Subject: Fallbrook PUD CZ #05085 AN #05019

Engineering Services has reviewed the submitted plans for Fallbrook PUD, located north of Hwy #34 and West of N. 1st Street, and has the following comments:

Subject: *Fallbrook review comments, CZ05085*

FALLBROOK PUD
 SITE PLAN

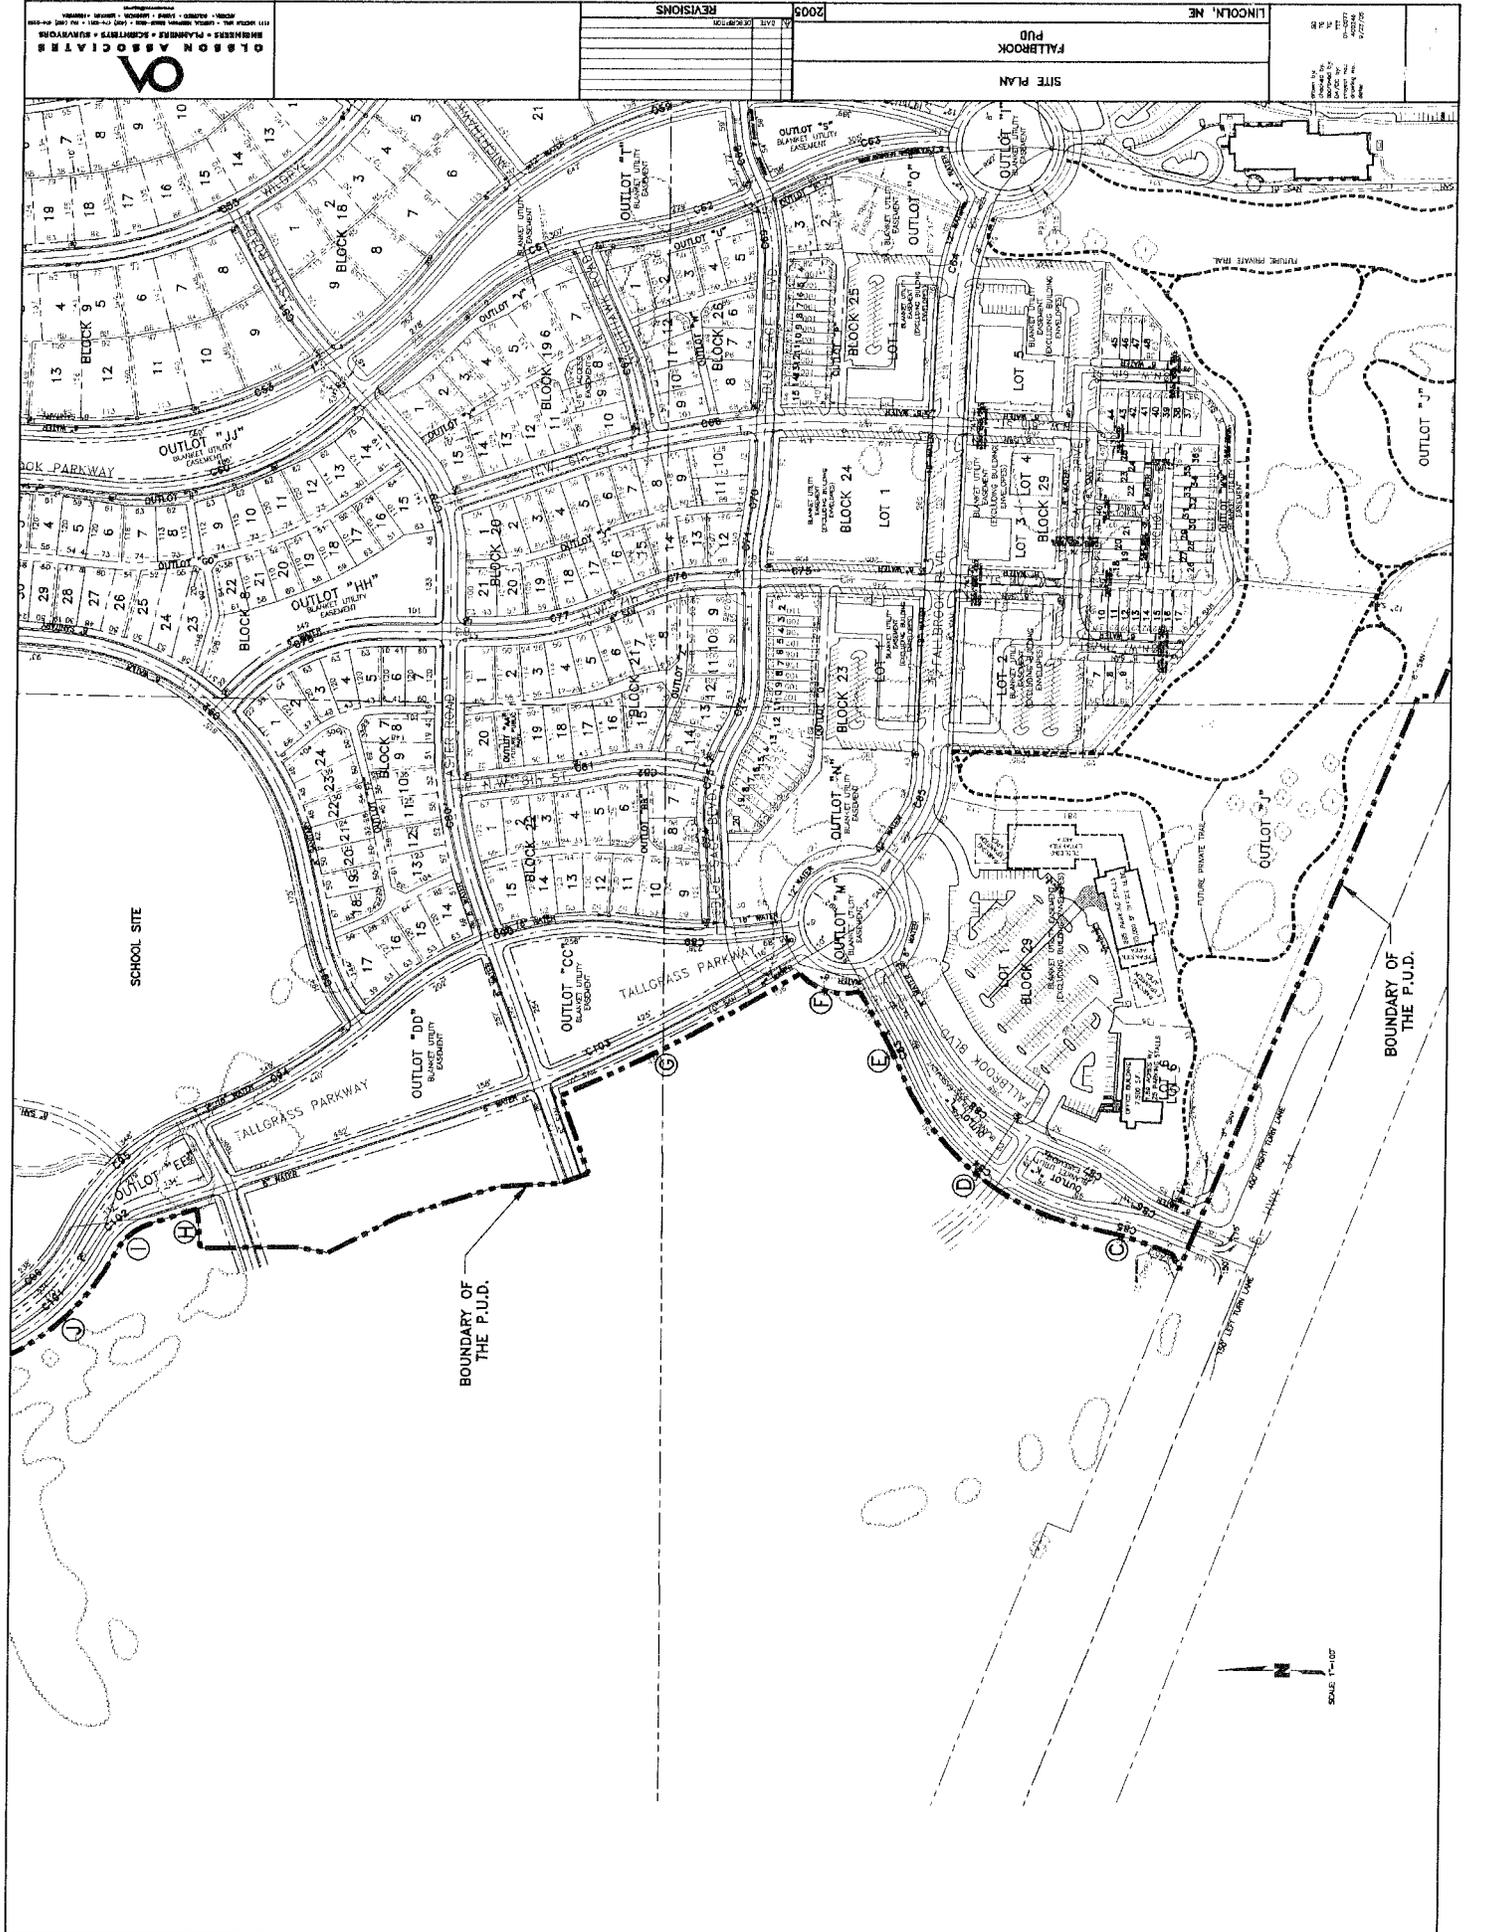
(3.1) It appears that the storm water discharge at the triple 9x4 culvert at the north end of Outlot 'DD' has increased by nearly 300 cfs for the 100 yr storm between the original drainage report and the recently submitted drainage report. This discrepancy needs to be addressed as down stream detention structures have been constructed based on the original drainage report.

(3.2) Stonebrook Parkway is shown inside the boundary of this PUD north of the intersection with Alvo Road. A profile needs to be shown along with the appropriate grading.

(4.1) The proposed profile for Alvo Road does not match the originally approved profile and does not meet arterial street standards. Intersection platform standards are not met at the intersection of N. 1st Street and Alvo Road. All of the vertical curves used for the proposed design of Alvo Road do not meet design standards for arterial design speeds. The proposed profile shows proposed grades in excess of the maximum 5-6 percent for arterial streets. The profile needs to be revised to meet all design standards for arterial streets. Also, the grading plans will need to be revised to reflect the revised profile.

(4.2) The vertical curve in Alvo Road at approximately Station 41+34 does not provide adequate site distance for the approach to the proposed roundabout.

(4.3) The vertical curve in northbound Stonebrook Parkway at approximately station 27+50 does not meet k-value design standards. The profile must be revised or a waiver of design standards needs to be requested and justified.

(4.4) A right turn lane needs to be shown at the intersections of Alvo Road with N. 1st Street and NW 12th Street. Also, 130' of ROW needs to be shown in Alvo Road at the intersections as per the approved Comprehensive Plan.

(4.5) It appears that both the NW 5th Street and NW 3rd Street connections to Alvo Road are not necessary. The original approved plat showed just one intersection between the proposed roundabout and N. 1st Street. NW 4th Street should be extended as the thru street and 5th and 3rd can tee intersect with silver leaf drive. If NW 5th and NW 3rd are to remain, NW 5th will need to be revised to show a right in right out only intersection. Full access should not be allowed at both intersections.

(4.7) The alley access to Alvo Road west of Lot 9 Block 2 is unsatisfactory to Public Works. The alley should connect to a revised street system north of Alvo Road.

(4.8) The proposed roundabouts in Alvo Road do not represent final intersection designs. Additional traffic analysis will need to be done to assess if the future traffic volumes and patterns will make these intersections good candidates for roundabouts on an arterial street. If the traffic analysis shows that roundabouts will function properly in these locations, a more detailed design will need to be completed to determine actual ROW needs. No lots adjacent to the proposed roundabouts should be final platted until a final design for the intersections are approved by Public Works.
